American Aviation Corporation
318 Bishop Road Cleveland, Ohio 44143

Accessory Kit No. AK-103A
(Supersedes Accessory Kit No. AK-103)

TITLE: Sun Screen Accessory Kit

MODELS AFFECTED: AA1-0001 and up, *AA1A-0001 and up.*

Figure 1: SUN SCREEN ASSY AND INSTALLATION

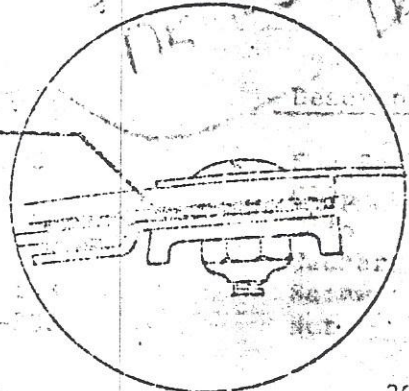
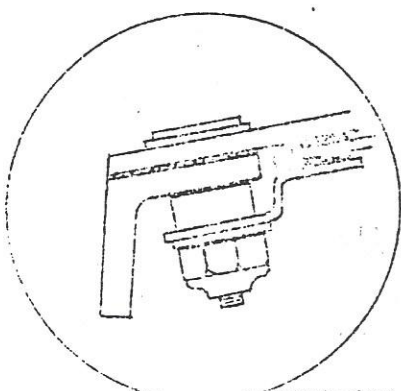
Changes: Added AA1A-0001 to MODELS AFFECTED. This kit is also applicable to the AA1A American Trainer
